## LUFDDYKTIGHETSÞÅBUD (LDP)

Seilfly  
LET-1

## LUFTDYKTIGHETSPÅBUD (LDP)

# MANDATORY BULLETIN

Fig. 1

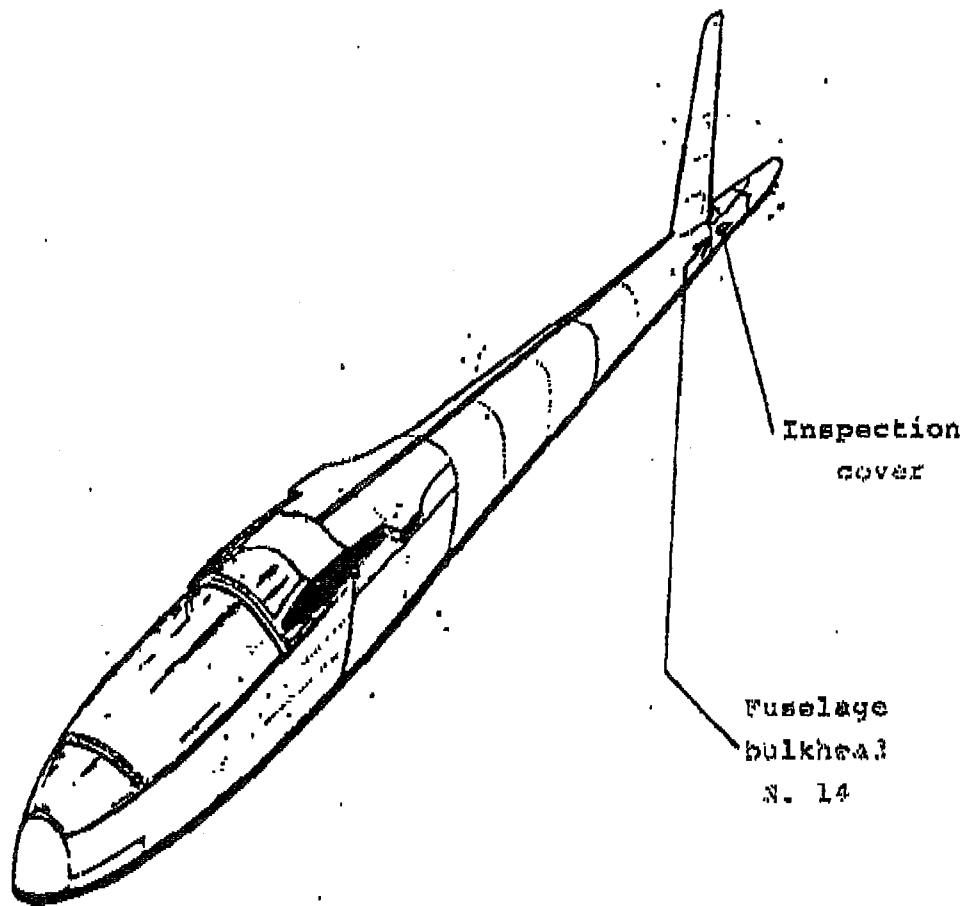
1. Remove the oval cover located on the LH side of the fuselage, under the horizontal stabilizer.
2. Test the material of the attachment fitting P/N A 102 021 N as follows:
  - a) Conductivity measurement by means of eddy currents:
    - Recommended measurement frequency: 60 kHz
    - Probe diameter: not exceeding 15 mm
    - Measuring contact point: lower milled surface of the component, between the rivets (see Figs 1 and 2).

- b) Hardness measurement by means of a portable digital hardness tester.  
Measuring method: depending on the type of the hardness tester used, i.e. dynamic, ultrasonic, and/or by means of a manual probe.  
Measuring point: lower milled surface of the component.  
Measured value: not lower than 100 HB.
- c) Any other measuring method must be approved by the sailplane manufacturer before it can be used.

Fig. 2

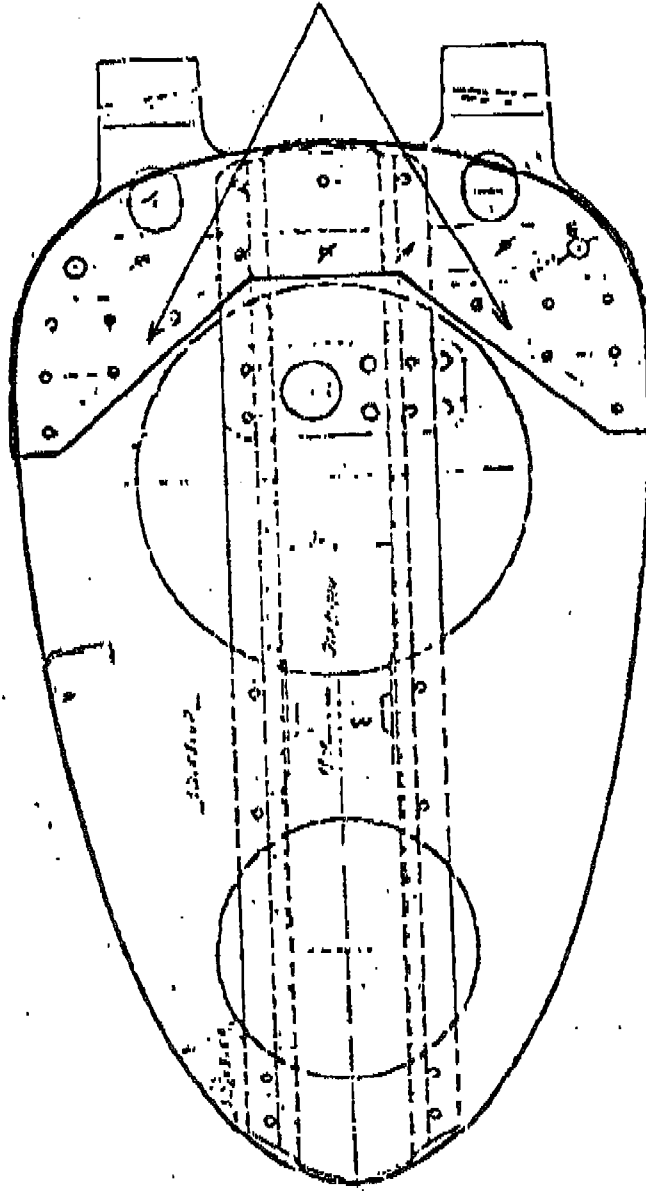
Fuselage bulkhead N. 14 with attachment fitting P/N  
A 102 021 N

Fig. 1

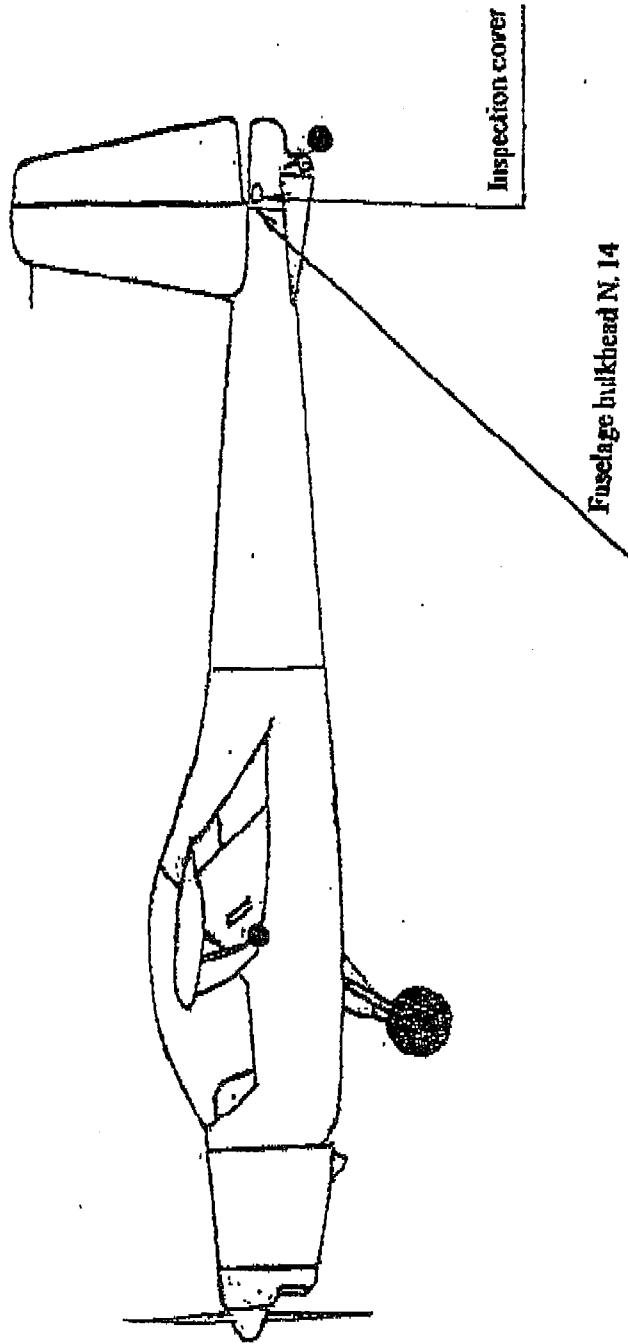
1. Remove the cover located on the LH side of the fuselage, under the horizontal stabilizer.
2. Test the material of the attachment fitting P/N A 102 021N as follows:
  - a) Conductivity measurement by means of eddy currents:
    - Recommended measurement frequency: 60 kHz
    - Probe diameter: not exceeding  $\varnothing$  15 mm
    - Measuring contact point:  
lower milled surface of the component, between the rivets (see Figs 1 and 2)

Measured value: not lower than 100 HB
  - c) Any other measuring method must be approved by the sailplane manufacturer before it can be used.
3.
    1. If the values measured during the check are within the permissible limits specified above, make a record in the powered sailplane log book (see section H of this Bulletin). The powered sailplane operation can be continued without any limitations.

Fig. 2

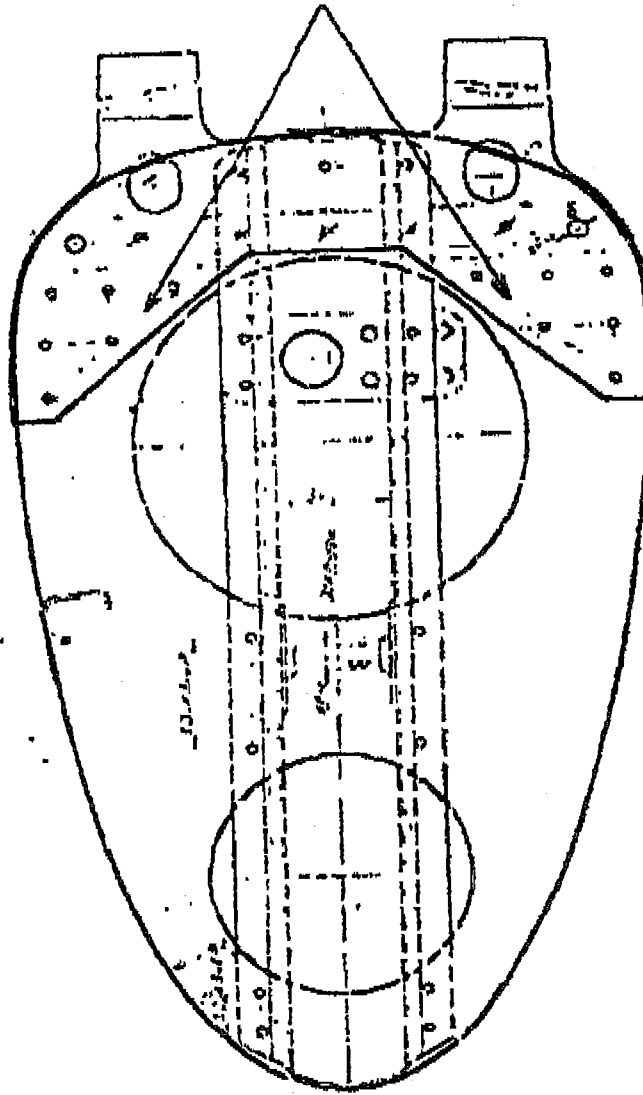
- Fuselage bulkhead N. 14 with attachment fitting P/N  
A 102 021 N
